**Condition B2**

**LORETO NORMANHURST BOARDING HOUSE**  
91-93 PENNANT HILLS ROAD  
NORMANHURST, NSW 2076

**BASEMENT PLAN**

1 : 200 @A1 | **DA2000 C**

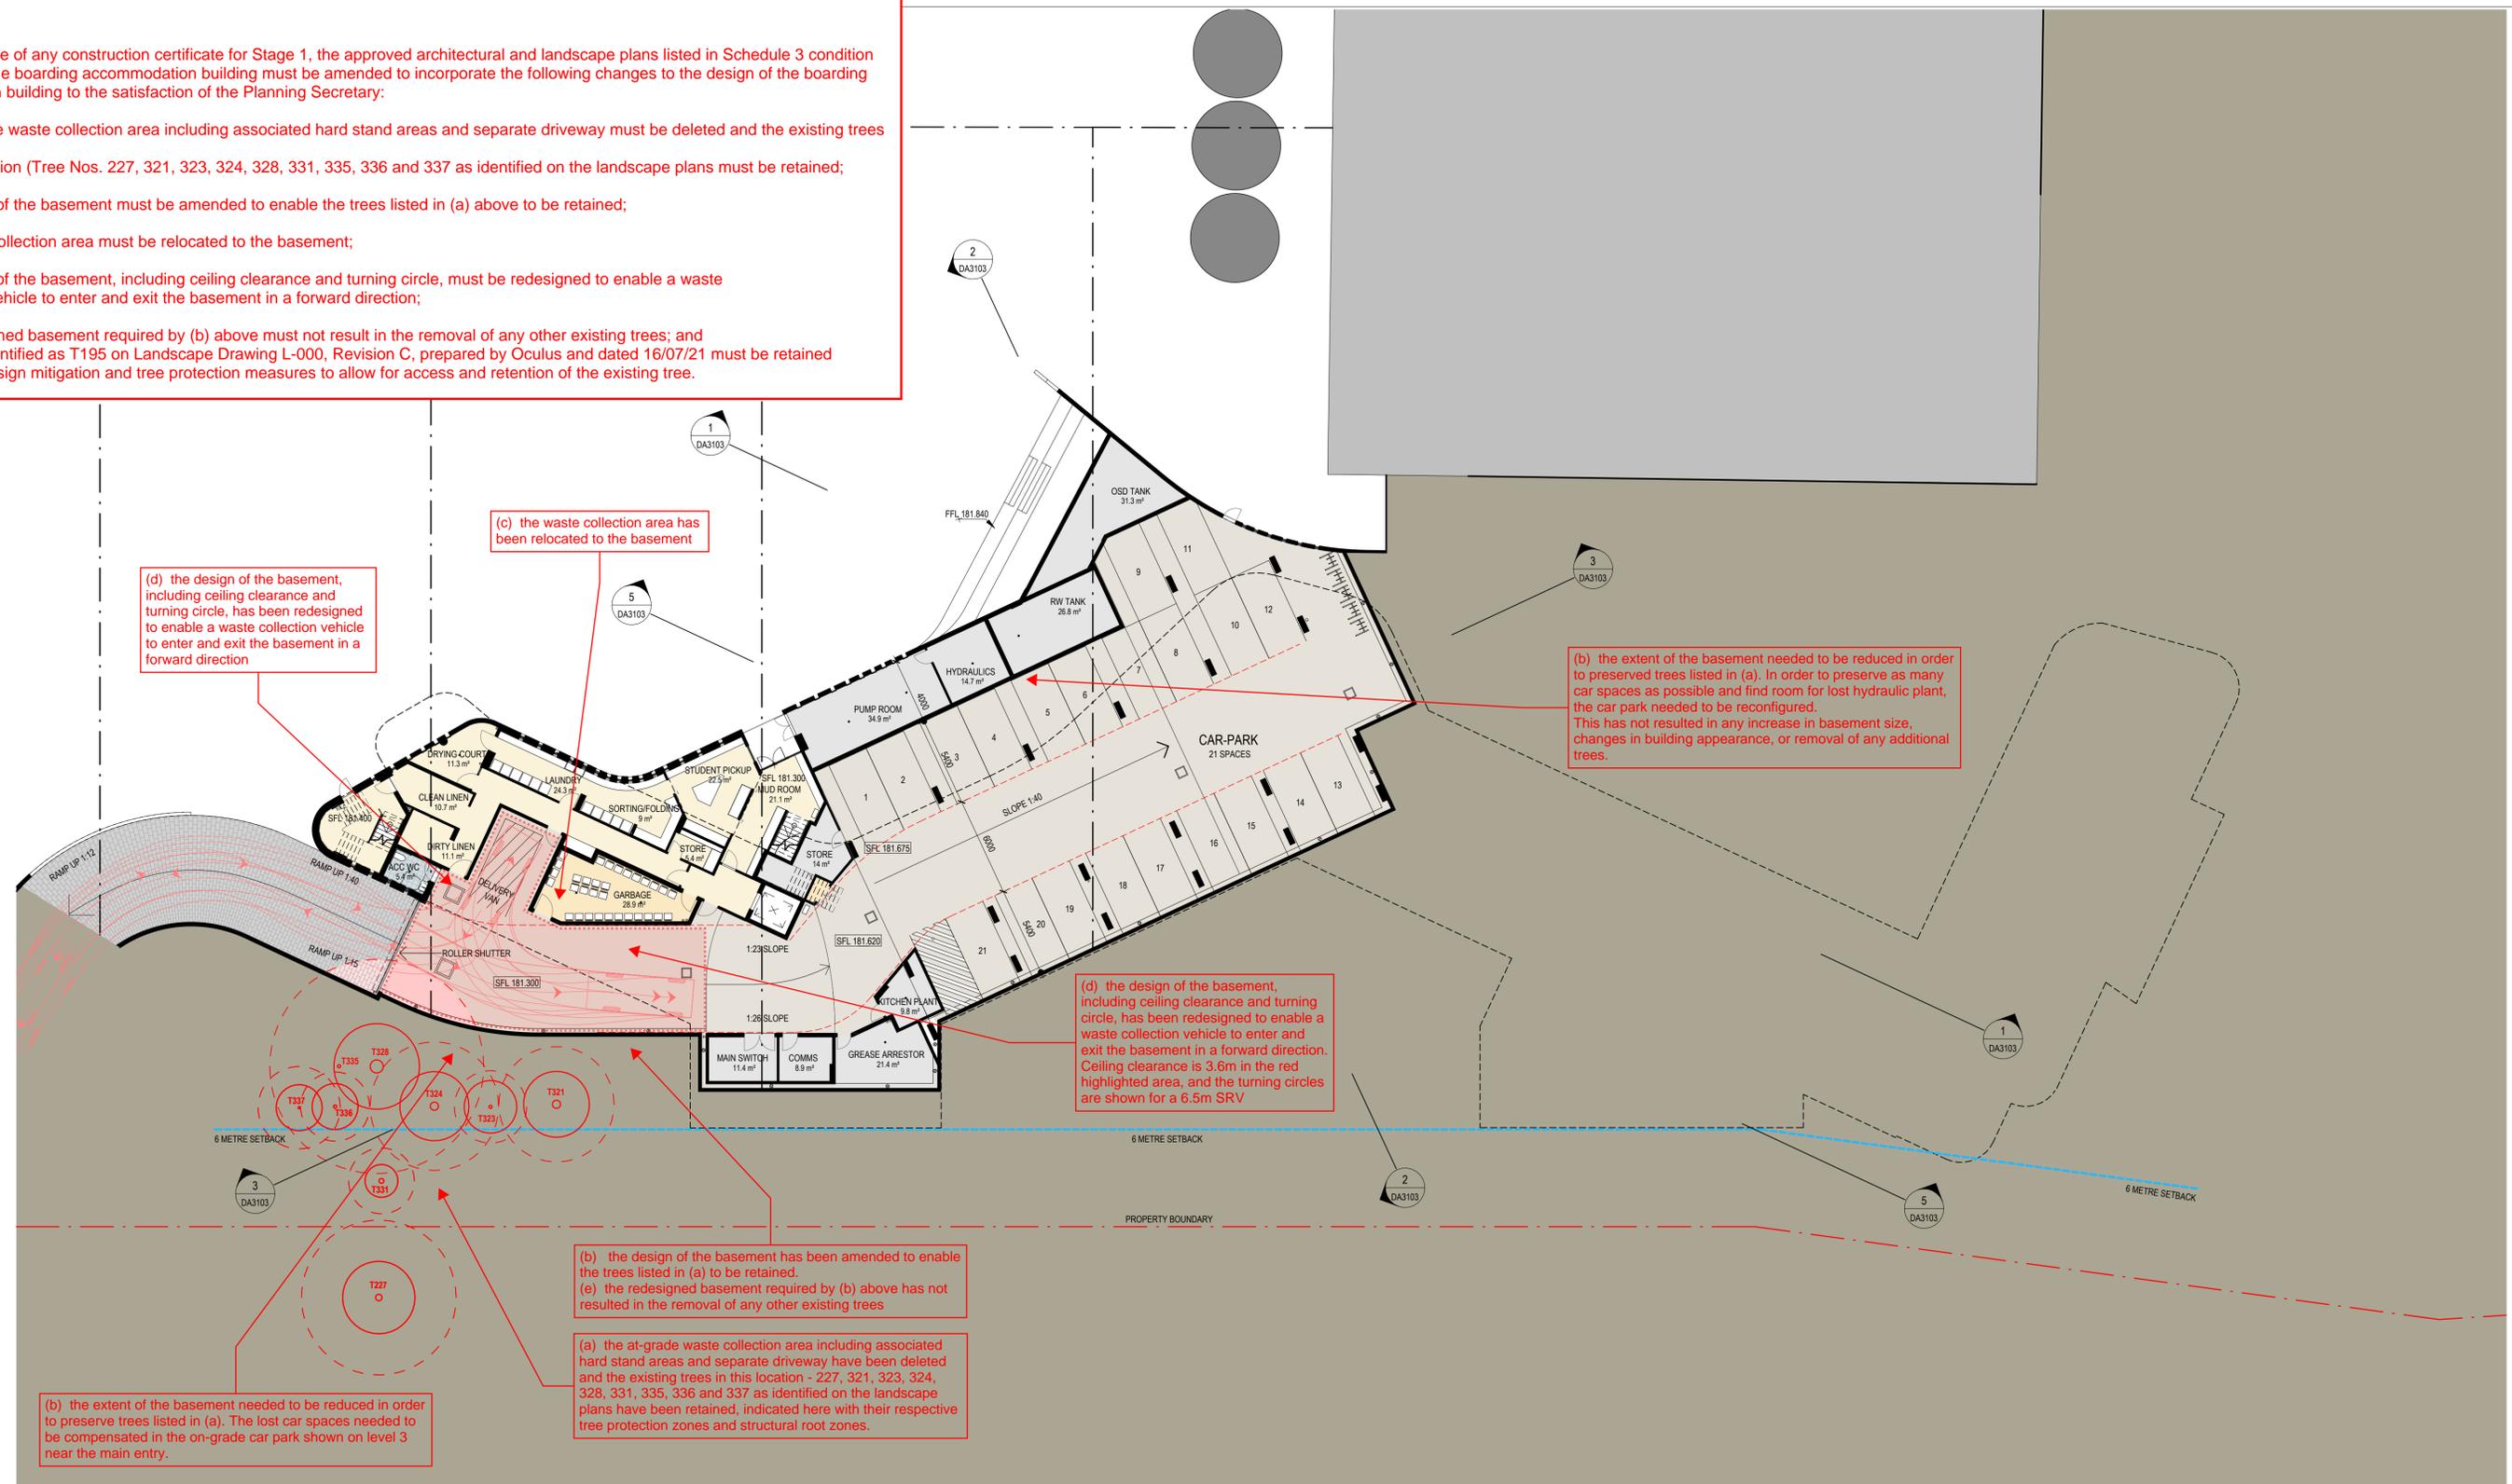
Prior to the issue of any construction certificate for Stage 1, the approved architectural and landscape plans listed in Schedule 3 condition A2 relating to the boarding accommodation building must be amended to incorporate the following changes to the design of the boarding accommodation building to the satisfaction of the Planning Secretary:

- (a) the at-grade waste collection area including associated hard stand areas and separate driveway must be deleted and the existing trees in this location (Tree Nos. 227, 321, 323, 324, 328, 331, 335, 336 and 337 as identified on the landscape plans must be retained;

- (b) the design of the basement must be amended to enable the trees listed in (a) above to be retained;
- (c) the waste collection area must be relocated to the basement;

- (d) the design of the basement, including ceiling clearance and turning circle, must be redesigned to enable a waste collection vehicle to enter and exit the basement in a forward direction;

- (e) the redesigned basement required by (b) above must not result in the removal of any other existing trees; and the tree identified as T195 on Landscape Drawing L-000, Revision C, prepared by Oculus and dated 16/07/21 must be retained through design mitigation and tree protection measures to allow for access and retention of the existing tree.

(d) the design of the basement, including ceiling clearance and turning circle, has been redesigned to enable a waste collection vehicle to enter and exit the basement in a forward direction

(c) the waste collection area has been relocated to the basement

(b) the extent of the basement needed to be reduced in order to preserve trees listed in (a). In order to preserve as many car spaces as possible and find room for lost hydraulic plant, the car park needed to be reconfigured. This has not resulted in any increase in basement size, changes in building appearance, or removal of any additional trees.

(d) the design of the basement, including ceiling clearance and turning circle, has been redesigned to enable a waste collection vehicle to enter and exit the basement in a forward direction. Ceiling clearance is 3.6m in the red highlighted area, and the turning circles are shown for a 6.5m SRV

(b) the design of the basement has been amended to enable the trees listed in (a) to be retained.  
(e) the redesigned basement required by (b) above has not resulted in the removal of any other existing trees

(a) the at-grade waste collection area including associated hard stand areas and separate driveway have been deleted and the existing trees in this location - 227, 321, 323, 324, 328, 331, 335, 336 and 337 as identified on the landscape plans have been retained, indicated here with their respective tree protection zones and structural root zones.

(b) the extent of the basement needed to be reduced in order to preserve trees listed in (a). The lost car spaces needed to be compensated in the on-grade car park shown on level 3 near the main entry.
